**SITE ADDRESS:** Seniors Living 69-71 Central Road, Avalon Beach, New South Wales, 2107.

**PROJECT** - Addendum to Arboricultural Impact Assessment (AIA) in relation to Section 4.55 Modification.  
Proceedings number 2018/146710 Development Application NO512/17

**Figure 1** –Excerpt of Ground Floor Plan, Dwg no. DA-03, Revision D-P9, dated 12 February 2024, authored by Gartner and Trovato Architects. (NOT TO SCALE).

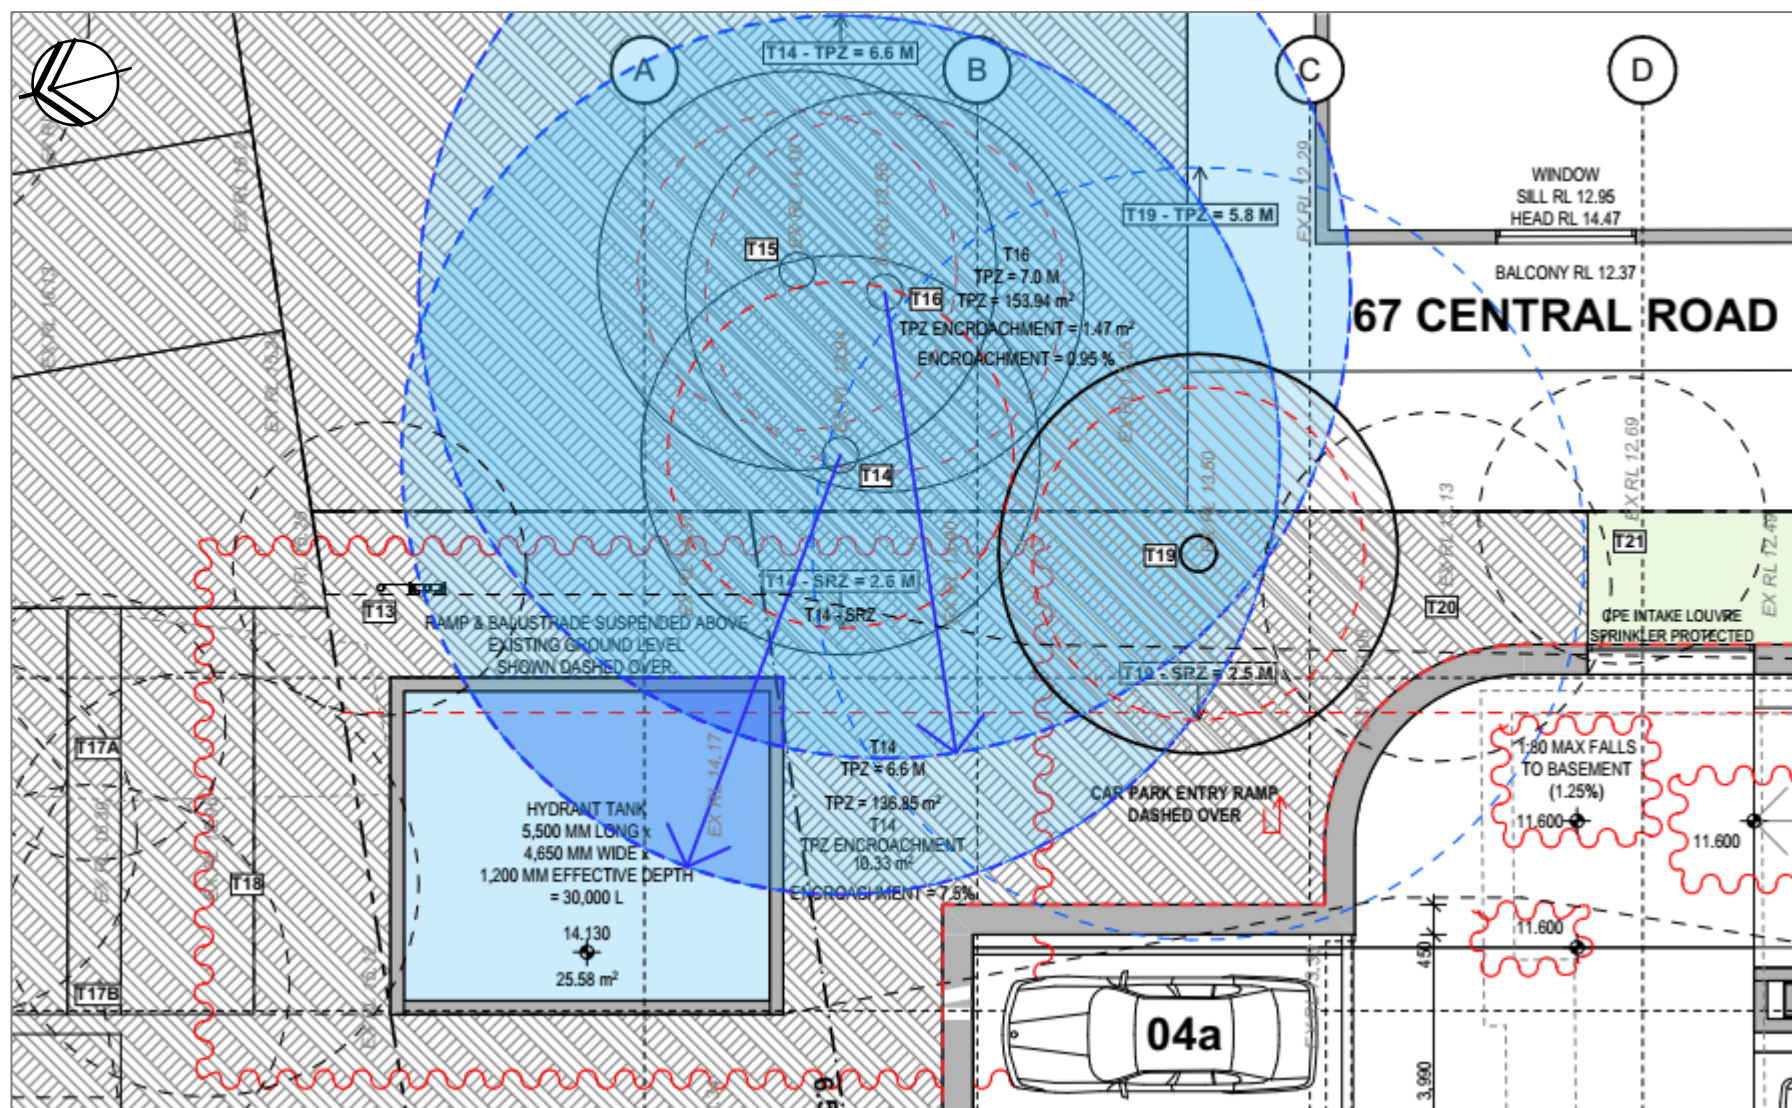
- An encroachment of 7.5% (see Appendix A, Figure 1) has been estimated for the proposed Hydrant tank located below the suspended driveway. This level of encroachment is considered *minor* under AS4970 and a reduction of this tree's assessed Useful Life Expectancy (ULE) is not foreseen.

- An encroachment of 1% (see Appendix A, Figure 1) has been estimated for the proposed Hydrant tank located below the suspended driveway. This level of encroachment is considered *minor* under AS4970 and impacts on tree health/condition are likely to be negligible.

**Figure 2** –Excerpt of Ground Floor Plan, Dwg no. DA-03, Revision D-P9, dated 12 February 2024, authored by Gartner and Trovato Architects. (NOT TO SCALE).

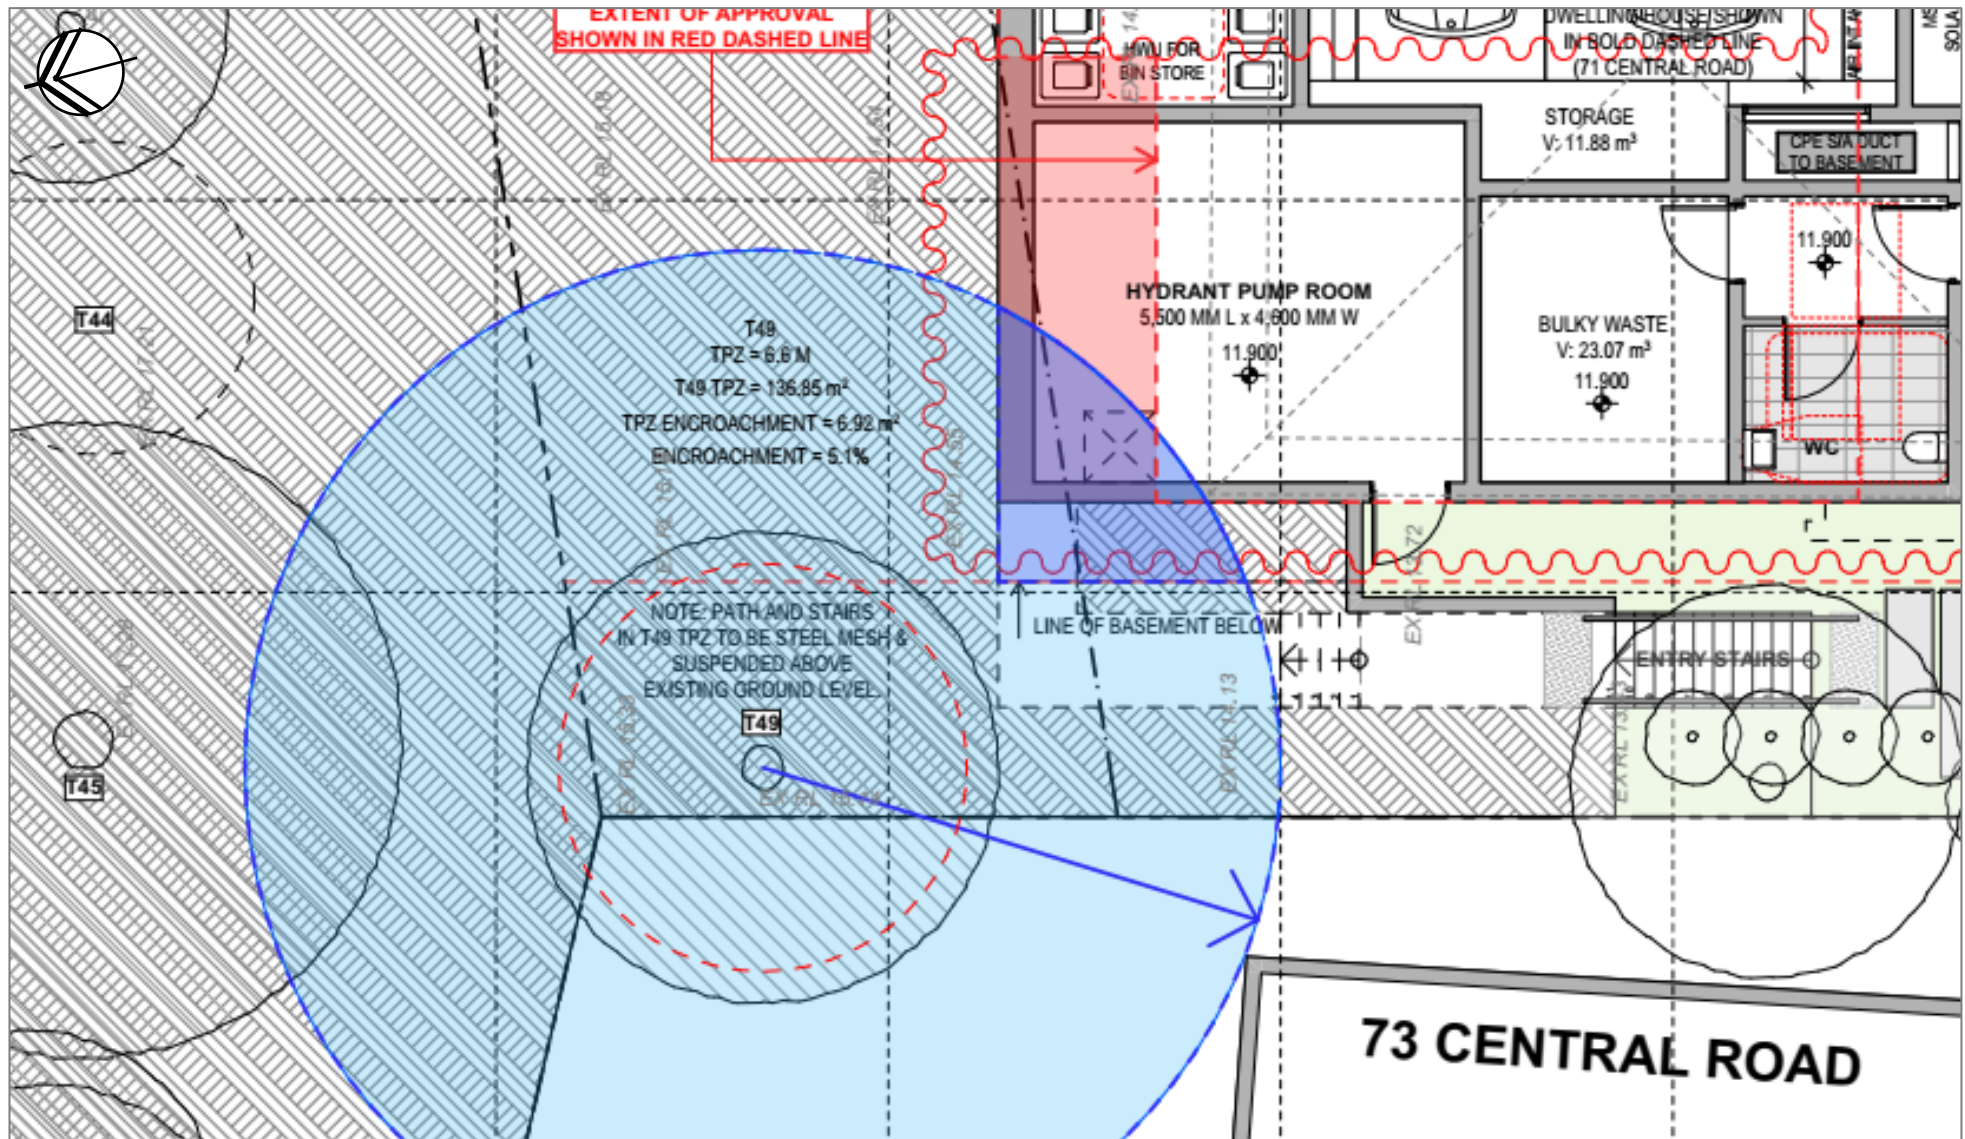
- An encroachment of 2.9% (see Appendix A, Figure 2) has been estimated for the proposed Hydrant Pump Room, but 5.1% (see Appendix B, Figure 3) has been estimated for the proposed basement amendment below. This level of encroachment is considered *minor* under AS4970 and a reduction of this tree's assessed Useful Life Expectancy (ULE) is not foreseen.
- The proposed path and stairs in Figure 2, Appendix A is noted as to be suspended above existing ground levels and has not been calculated within the incursion. Project Arborist supervision for any isolated footings will be required.

**Project Arboriculturist** – The Tree Protection Plan notes that all works within the calculated Tree Protection Zones requires PA notification. Any potential tree impacts resulting from the proposed amendments can be managed at this time.
